Access Compliance Report

Public Rights-of-Way

Intersection ID: 28659	Main Street: HAMPTON_PLACE_DR	Cross Street: RIDGELINE_LN	Location:	E
ADA ID: E42D90E1C45A	Ramp Type: PerpDiag	Initial Pass/Fail: Fail	Overall Compliance: No	Severity Score: 10
Codes/Mitigation Info/Possible Solution		Field Measurements/Component Compliance

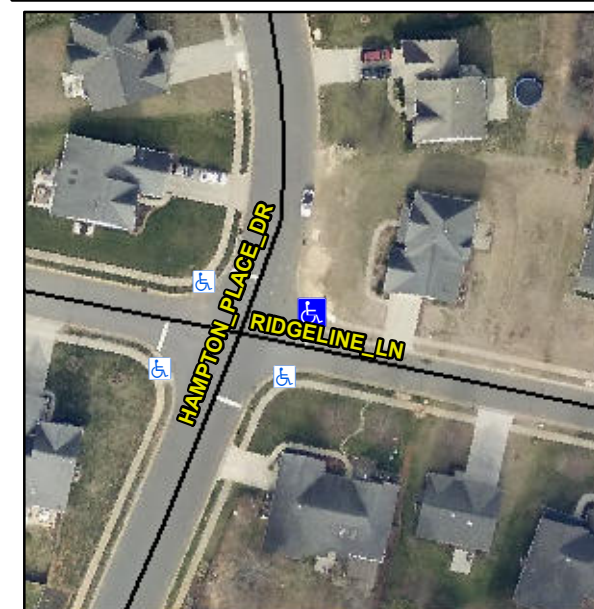
Not Found, R304.5.1, R304.5.3

Compliance	Description	Data	Compliance	Description	Data
N/A	Ramp Length (in)	48.5	Yes	Ramp Slope (%)	5.1
No	Ramp Width (in)	47.0	No	Ramp XSlope (%)	4.1
N/A	Flare Type LT	N/A	N/A	Flare Type RT	N/A
N/A	Flare Slope LT (%)	N/A	N/A	Flare Slope RT (%)	N/A
N/A	Flare Traversable LT?	N/A	N/A	Flare Traversable RT?	N/A
N/A	Landing Length (in)	N/A	N/A	DWS Provided?	N/A
N/A	Landing Width (in)	N/A	N/A	DWS Contrast?	N/A
N/A	Landing Slope (%)	N/A	N/A	DWS Length (in)	N/A
N/A	Landing X Slope (%)	N/A	N/A	DWS Full Width?	N/A
N/A	Landing Curb? (Y/N)	N/A	N/A	DWS Offset (in)	N/A
N/A	Shared Landing?	N/A			
N/A	Gutter Ponding?	N/A	N/A	Gutter Slope (%)	N/A
N/A	Gutter Lip Ht (in)	N/A	N/A	Gutter X Slope (%)	N/A
N/A	Painted X Walk1?	No	N/A	Painted X Walk2?	No
	X Walk 1 Direction	To NW		X Walk 2 Direction	To SW
N/A	X Walk 1 Width (in)	N/A	N/A	X Walk 2 Width (in)	N/A
	X Walk 1 Slope (%)	2.4		X Walk 2 Slope (%)	0.3
	X Walk 1 X Slope (%)	0.7		X Walk 2 X Slope (%)	3.3

Remove & Replace Curb Ramp With Two New Directional Ramps or Equivalent.
